ADDENDUM No. 3

Date May 18, 2016

Project Name: Waters Park Relief Main & Southern Portion of Northern Walnut Creek Trail Phase 1A

C.I.P. No. 3168.039

SHEET NUMBER 15 OF 82

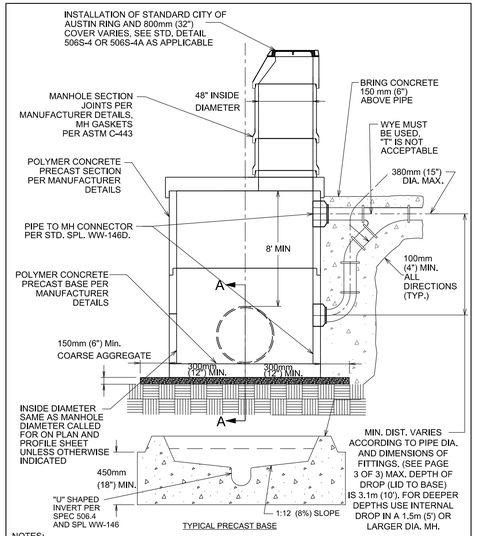
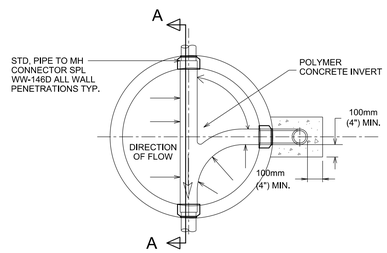
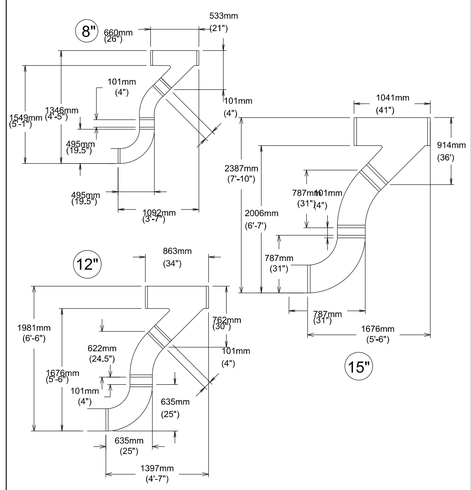
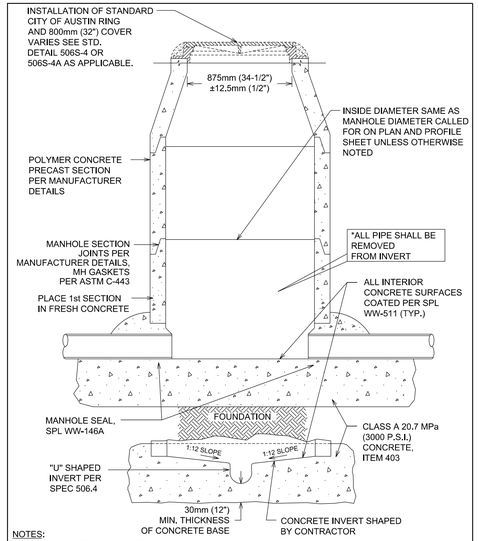
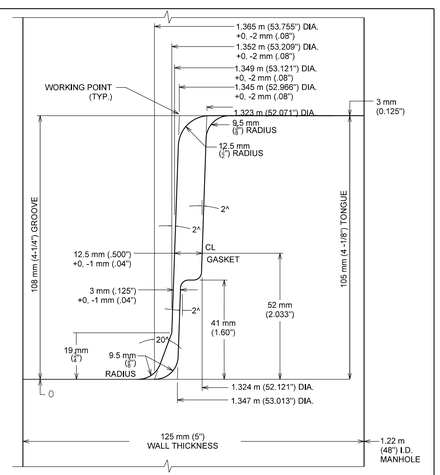
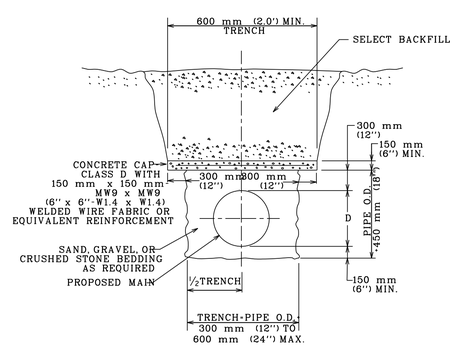
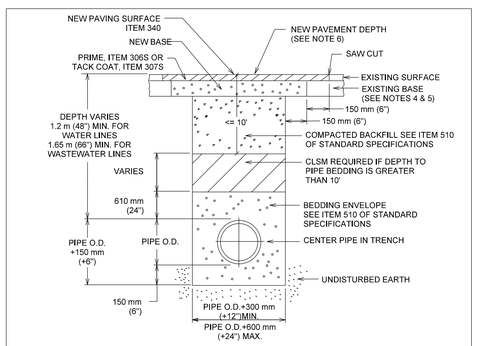
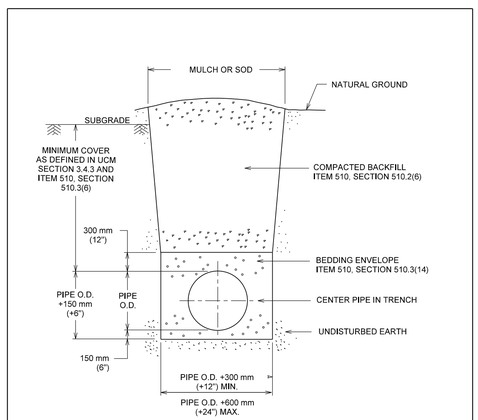
REV. NO.	BY	DATE	REVISION DESCRIPTION
1	TO	5/17/16	ADDENDUM #3 - REPLACE DETAIL

SHEET NUMBER 21 OF 82

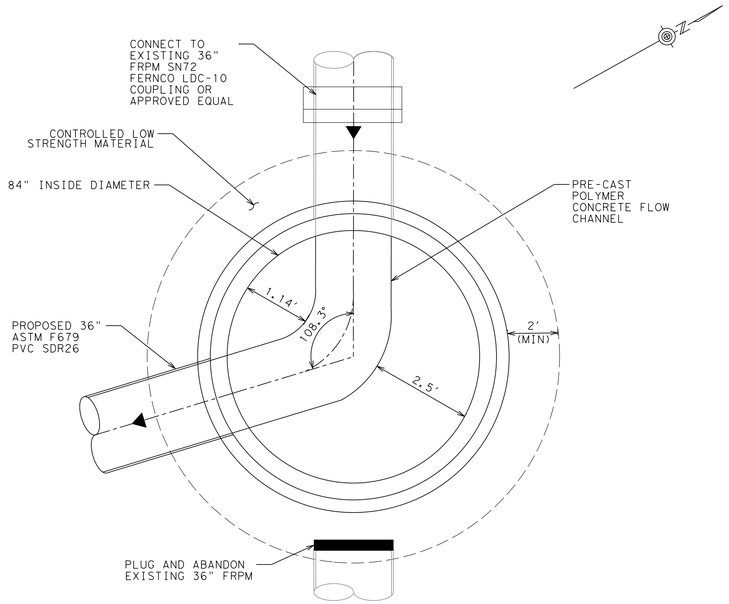
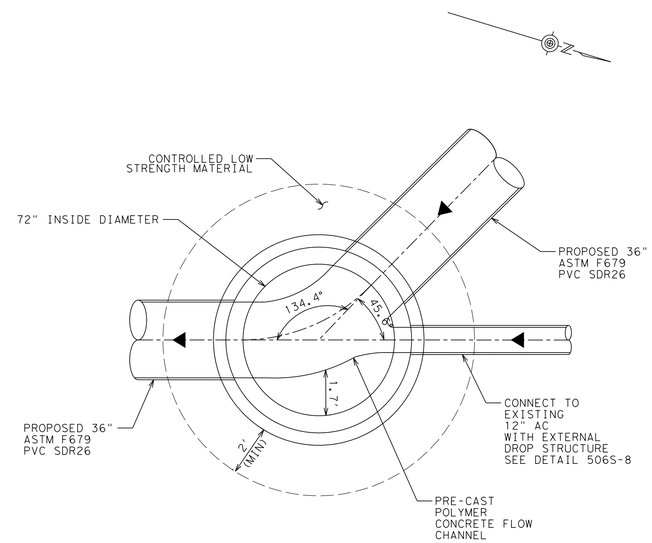
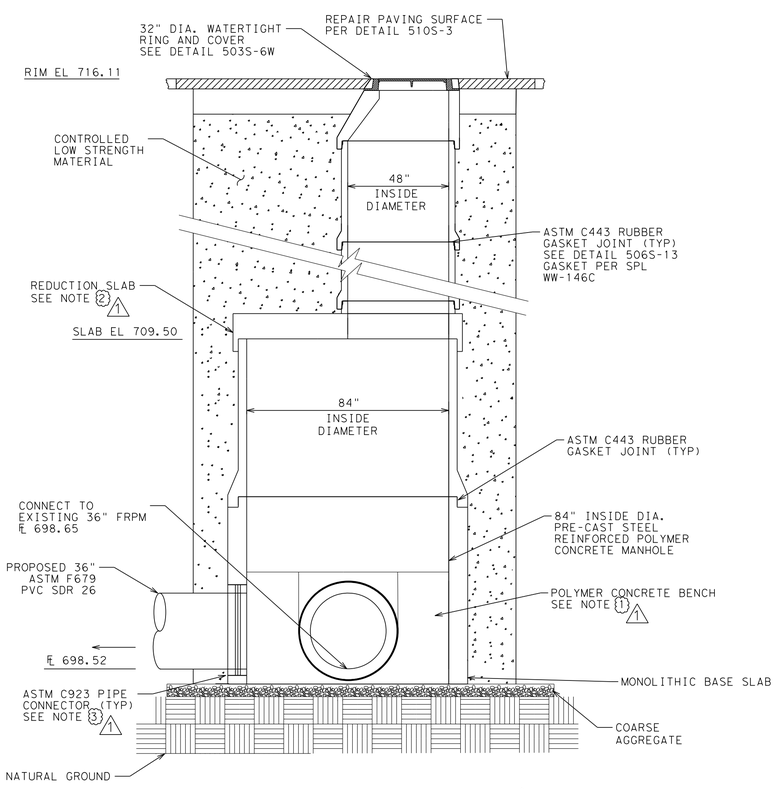
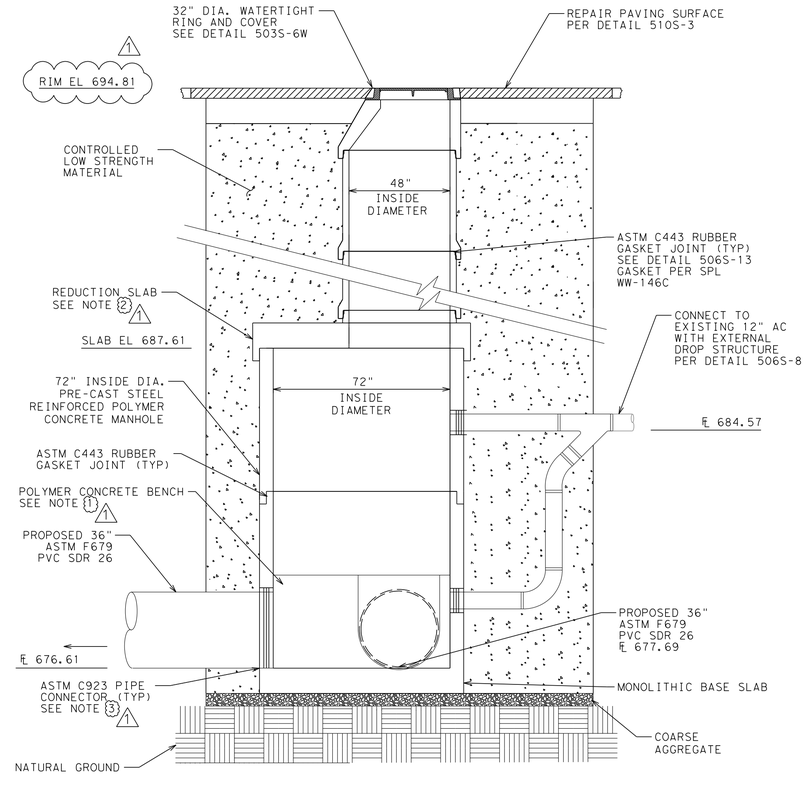
REV. NO.	BY	DATE	REVISION DESCRIPTION
1	TO	5/17/16	ADDENDUM #3 - REVISE CALLOUTS
